**Addendum No.:** 2

**Bid#:** 24-39-2

**Project Name:** Meadow Lake New Storage Tank

**SITE PLAN**  
SCALE: 1" = 10'  
1" = 10 FEET

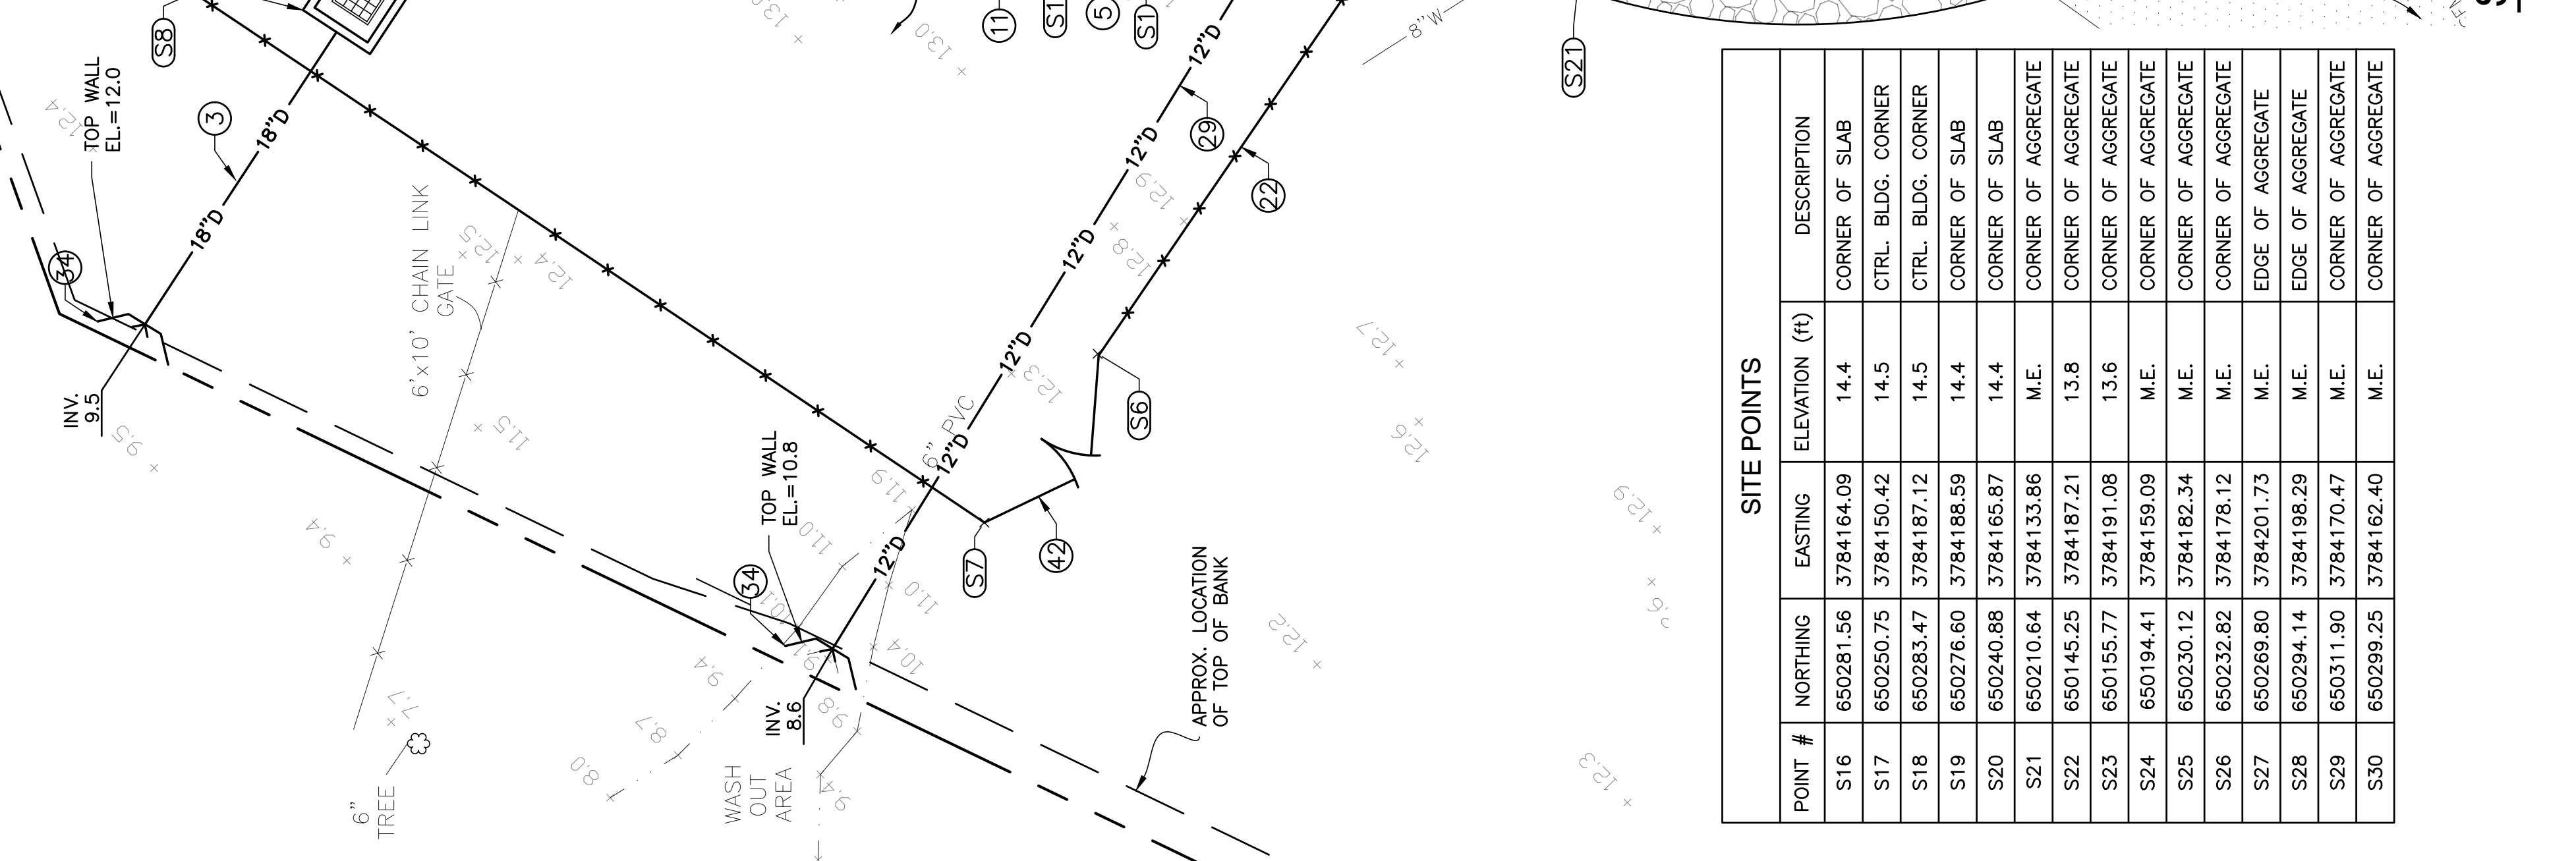
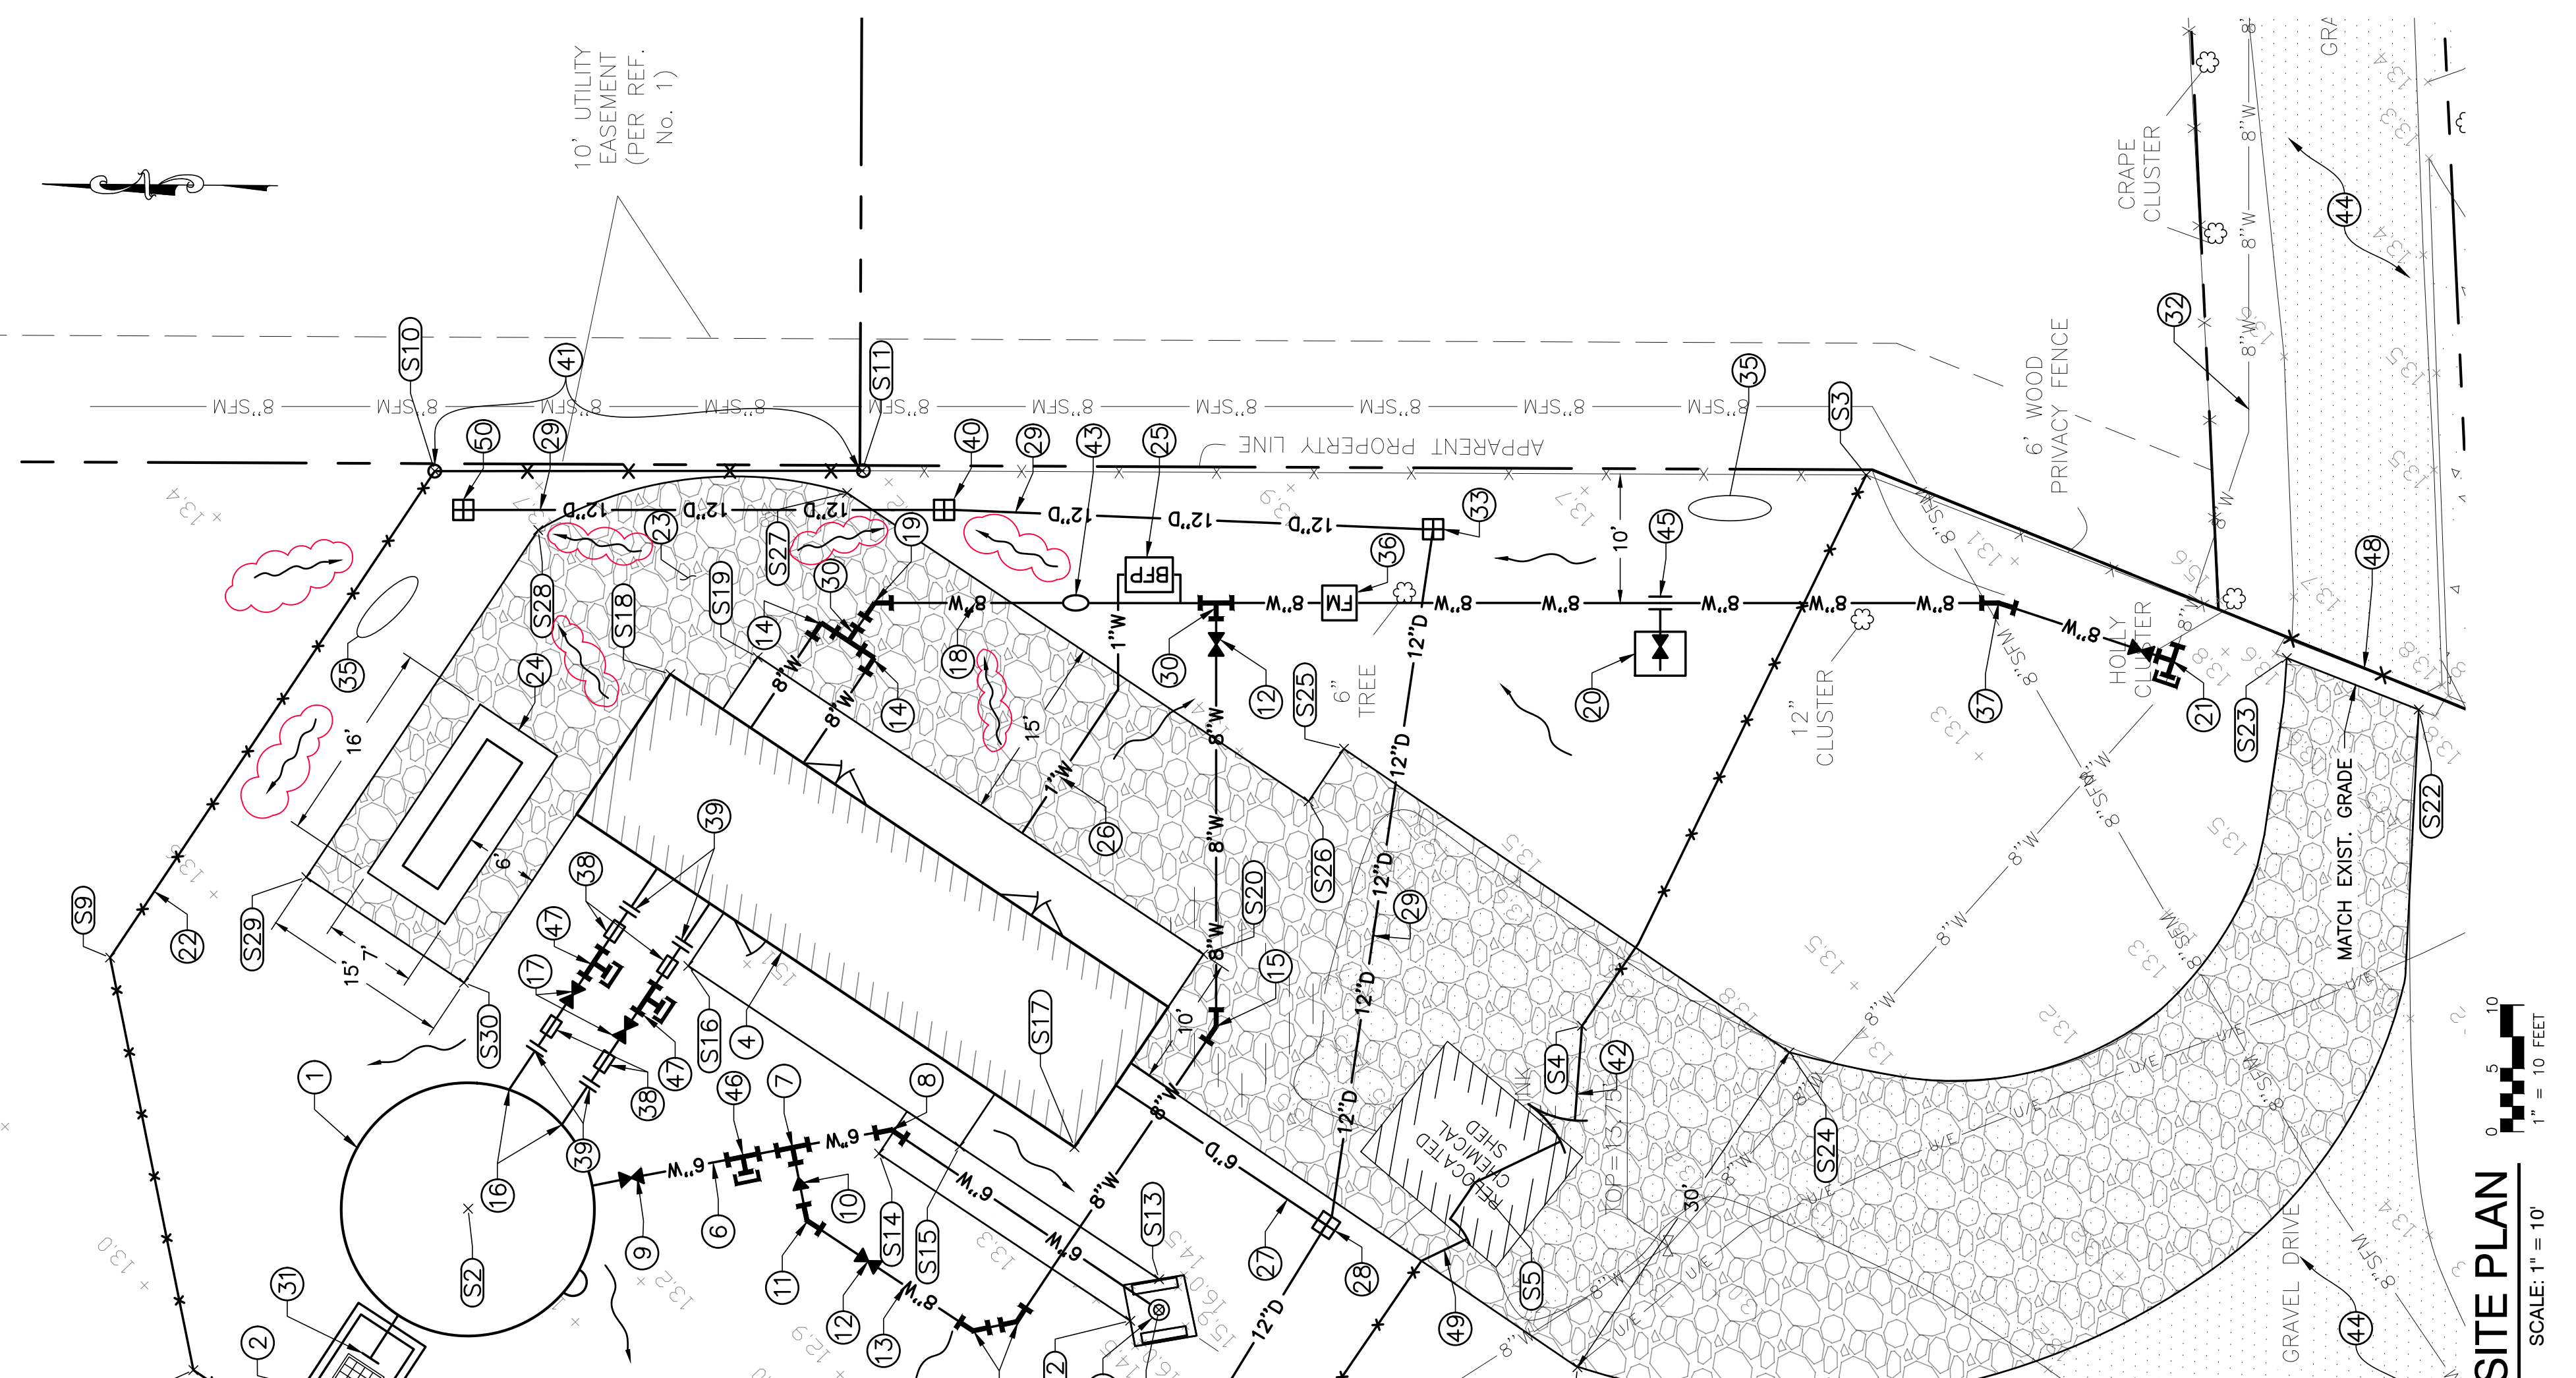
- a. **Replace** Drawing Sheet 5- “Meadow Lake Site Plan” with Drawing Sheet 5 - “Meadow Lake Site Plan – Addendum No. 2”.

NO.	DESCRIPTION OF REVISION	DATE
2	ADDED APPROX. T.O.B.	9/6/24
1	ADDITIONAL SURFACE FLOW ARROWS.
